UNITED STATES PATENT AND TRADEMARK OFFICE

APPLICATION NO.	FILING DATE	FIRST NAMED INVENTOR	ATTORNEY DOCKET NO.	CONFIRMATION NO.
10/730,834	12/08/2003	Nick Kuo	JCLA11759	5204

Office Action Summary

DETAILED ACTION

FIG. 1D

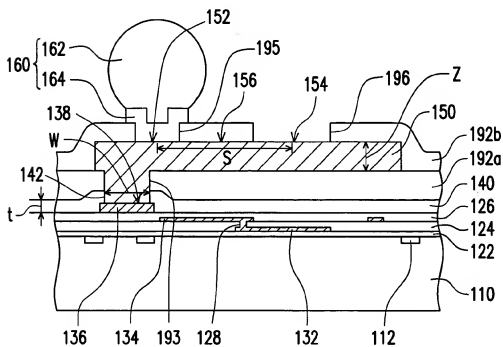
2. Applicant's election without traverse of species 4 (figs. 1d and 2d) in the reply filed on 9/07/2005 is acknowledged
